UN#09-389

Subject: UniStar Nuclear Energy, NRC Docket No. 52-016
Response to Request for Additional Information for the
Calvert Cliffs Nuclear Power Plant, Unit 3,
RAI No. 130, Basic Geologic and Seismic Information and
RAI No. 134, Basic Geologic and Seismic Information

**Response to NRC Request for Additional Information,
RAI No. 130, Basic Geologic and Seismic Information,
Questions 02.05.01-33 through 02.05.01-56,
Calvert Cliffs Nuclear Power Plant Unit 3**

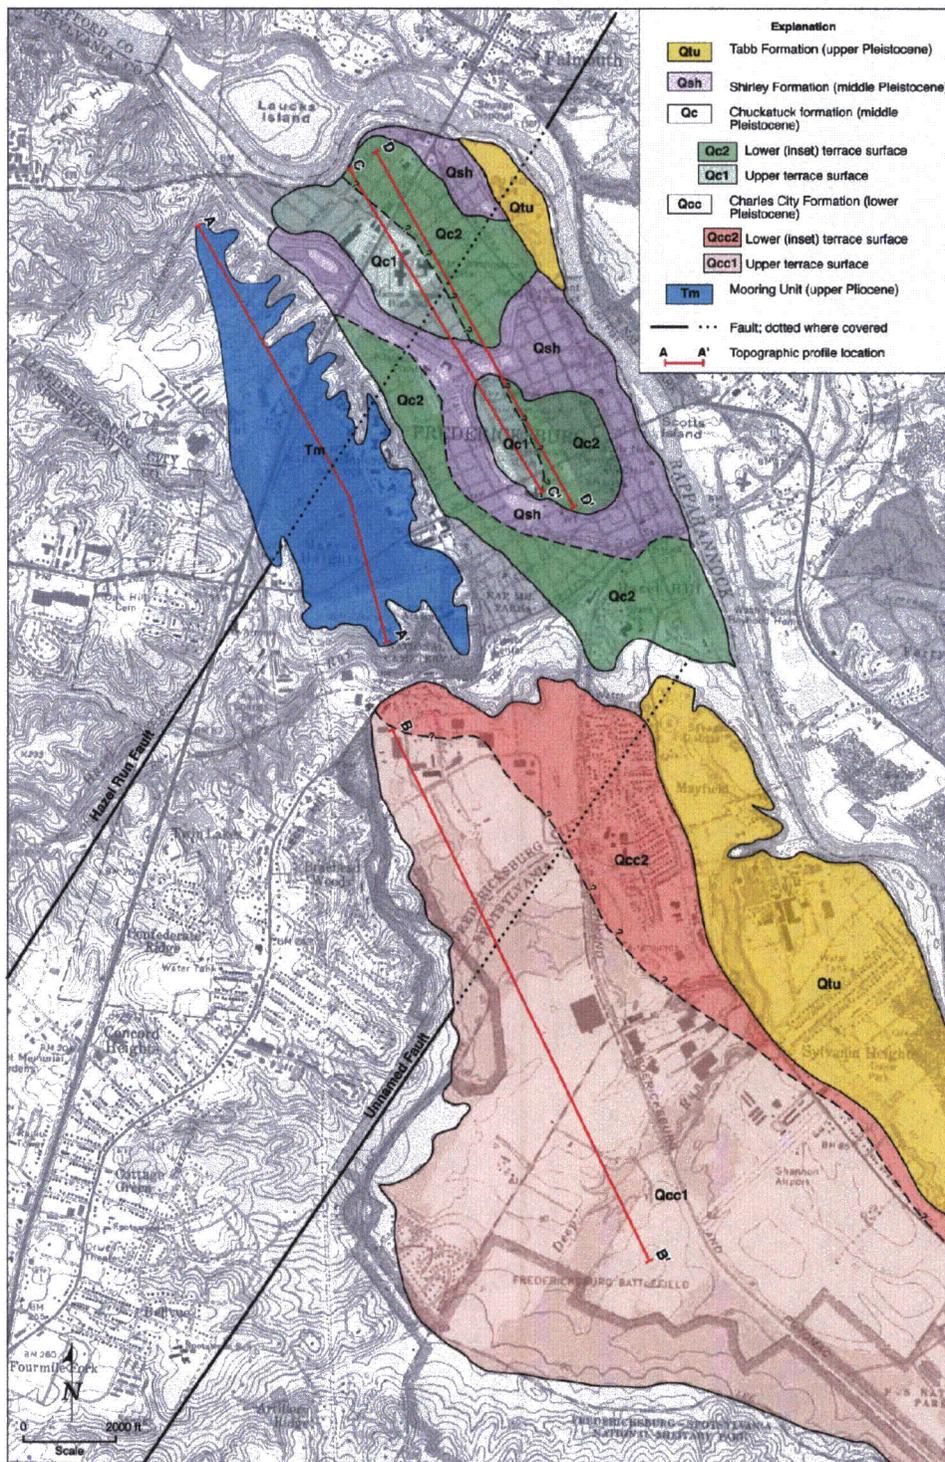
The Miocene Calvert Formation is also undeformed where it crosses the Dumfries fault (Dominion, 2004a). Along a linear transect across the Dumfries fault, maximum elevations of the Calvert Formation define a planar, unfaulted surface dipping gently to the southeast with a dip of 0.4° (Figure 7). This planar Miocene surface was interpreted by Dominion (2004a) to indicate that the Dumfries has not been active since the Miocene.

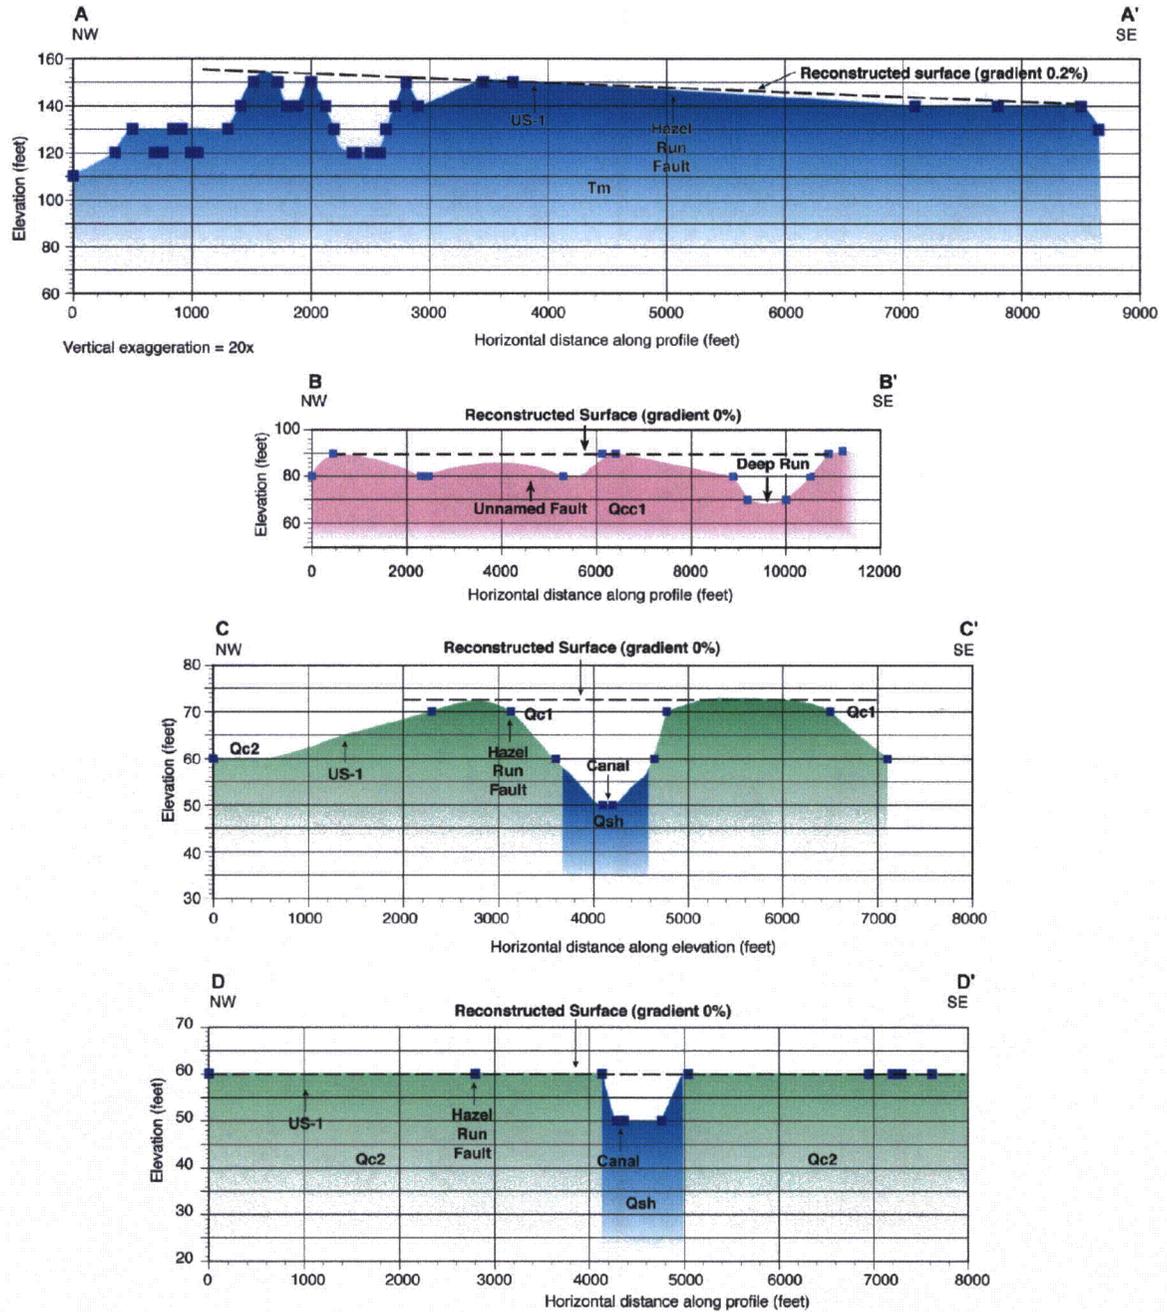
Several terraces along the south bank of the Rappahannock River were examined for evidence of deformation where they intersected the Stafford fault system (Figure 8) (Dominion, 2004a). The elevation of three Pliocene and Pleistocene terrace surfaces were examined across the Hazel Run fault and one Pleistocene terrace was examined across the unnamed fault (Figure 8). In the four transects, the reconstructed Pliocene and Pleistocene surfaces were planar and undeformed, indicating faulting on these structures had ceased by Pliocene time (Figure 9).
